**Final Environmental Impact Report  
for the  
Rincon Phase 2 Decommissioning Project**

**State Clearinghouse No. 2022100043  
CSLC EIR Number: 815**

**July 2024**

<b>TABLE OF CONTENTS</b> .....	<b>I</b>
<b>APPENDICES</b> .....	<b>IX</b>
<b>LIST OF ABBREVIATIONS AND ACRONYMS</b> .....	<b>XV</b>
<b>PART I - PREFACE TO THE FINAL ENVIRONMENTAL IMPACT REPORT</b> .....	<b>I-1</b>
PURPOSE .....	I-1
ORGANIZATION OF THE FINAL EIR .....	I-1
PROJECT DESCRIPTION.....	I-2
DECISION-MAKING PROCESS .....	I-2
PROJECT CEQA CHRONOLOGY .....	I-3
<b>PART II. RESPONSES TO COMMENTS</b> .....	<b>II-1</b>
SUBPART II.A. Written Public COMMENTS AND RESPONSES .....	II-4

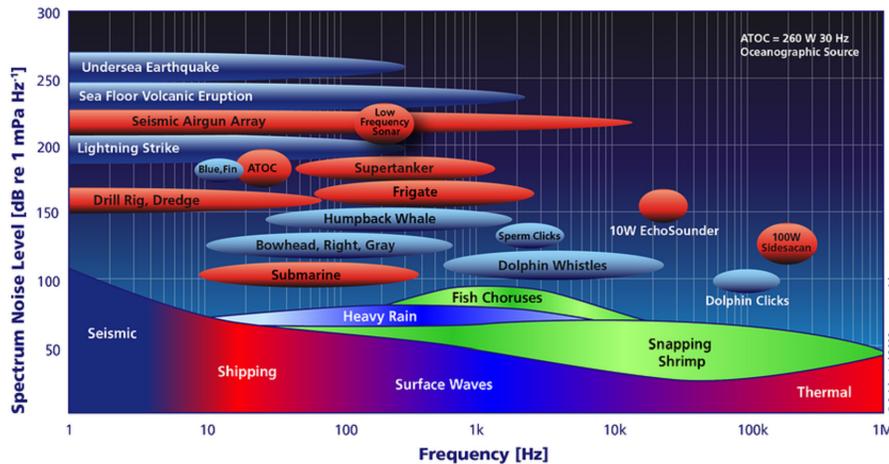
Section 4.11 needs to address underwater noise in the ocean. Appendix D4 shows the presence of dolphins and whales. Noise of any work carried out on the island will carry in the water. Breaking the 3” concrete with “hydraulic claw, cutter, shear, and breaker attachments” (p.2-19) will be noisy. The underwater effects of that and other noise need to be evaluated, mitigated, and will probably need “take” permits under federal and state rules which protect marine mammals (e.g., pp.B-16, B-27, B-20).

Whales and dolphins produce and can be disturbed by a wider range of frequencies than the ones described for humans in the DEIR (p.4-245). This graph shows the frequencies they produce. There is other research which shows they hear and react to much lower decibel levels, in this same wide range of frequencies.

Figure 2-23. Option 2: Native Revegetation, Access Improvements, and Installation of a Cobble Back Berm

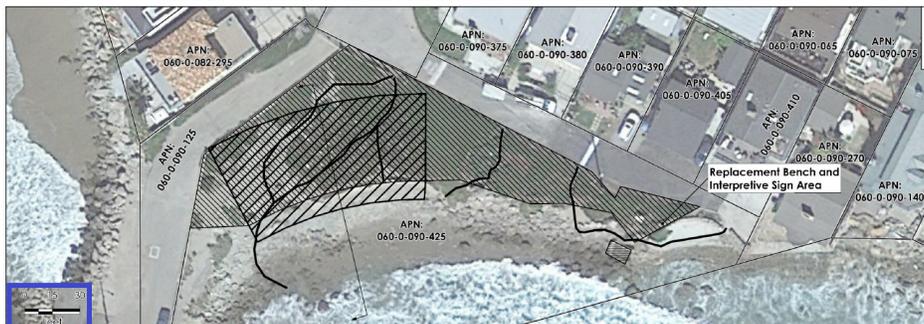
The DEIR proposes an option of a small area of cobbles, with edges in front of the homes and near the causeway. The DEIR cites no research on edge effects of small areas of cobbles, and needs to analyze whether the placement of cobbles or riprap to protect the road will displace forces to erode in front of the homes. The state also needs a process to coordinate with any protections the homeowners undertake. If the adjacent property owners protect their homes privately, they will choose and take responsibility for the methods, and they need to be coordinated.

“[A]gencies subject to CEQA generally are not required to analyze the impact of existing environmental conditions on a project’s future users or residents. But when a proposed project risks exacerbating those environmental hazards or conditions that already exist, an agency must analyze the potential impact of such hazards on future residents or users” (pp.4-136, 4-160). The past project does not appear to exacerbate hazards: “aerial photographs of this area, spanning nearly a century, indicate that the shoreline and beaches both upcoast and downcoast of Punta Gorda and Mussel Shoals have not been impacted by the construction of the causeway” (p.5-46). Effects of replacing existing vegetation and installing cobbles or riprap could impact neighbors.

- The proposed option of cobbles will see them move “upward and landward” (pp.7-5, G2-23), spreading onto the access road and adjacent properties. Surfer’s Point has cobbles and has moved an average of two feet inland per year in its first 10 years (p.G2-25). The caption of Fig.27 calls 2’/year “little change.” When it cuts into a road, 2’/year is significant. As storms get stronger and sea level rises, inland movement will accelerate. The EIR needs to offer a plan to protect the access road from being eroded away by this upward and landward movement, going at least 2 feet per year.

Figure 27. Profile 3 across dunes and shoreline at Surfer's Point built over the 10-year period from 2011 to 2021 showing stability and little change on the upper portion of the profile where cobbles were placed and dunes were constructed.

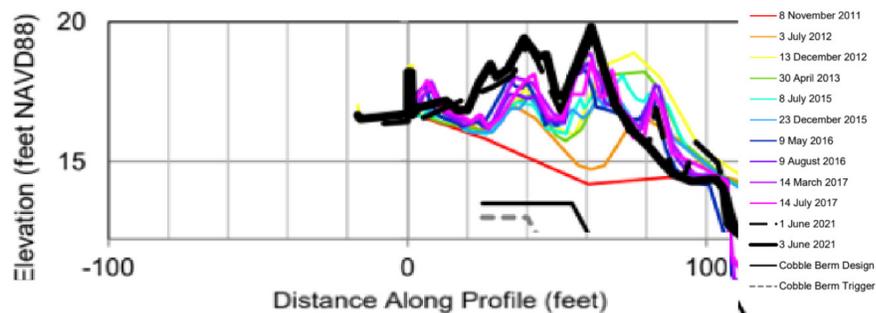
- The proposed option of riprap “has occurred periodically over the years” (p.4-166), without working long term, and certainly cannot suddenly begin to protect against an ocean which is higher and stormier. The EIR needs to offer a plan to protect the access road from repeated loss of the riprap.

### Comment 21-5

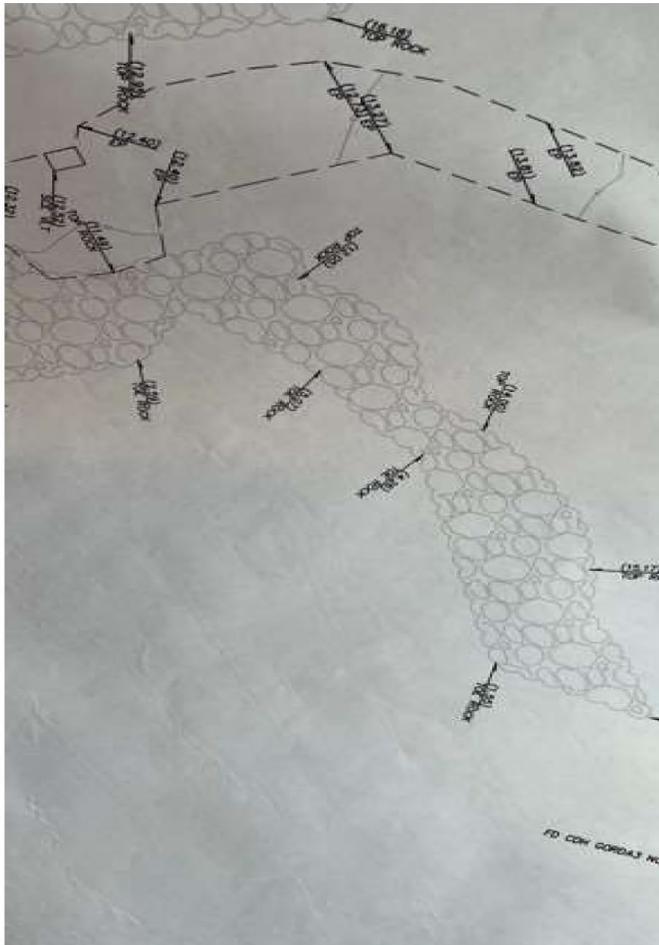
- Bluff elevation – If option 3 is chosen and rip rap will be used to protect the SCC parcel, the existing elevation needs to be maintained for drainage purposes. If the bluff elevation is raised water will not sheet into the ocean as it does today. A recent survey of the bluff area is provided on the next page:

As you will note, the bluff height varies from elevation 15' to 11' when moving east to west.
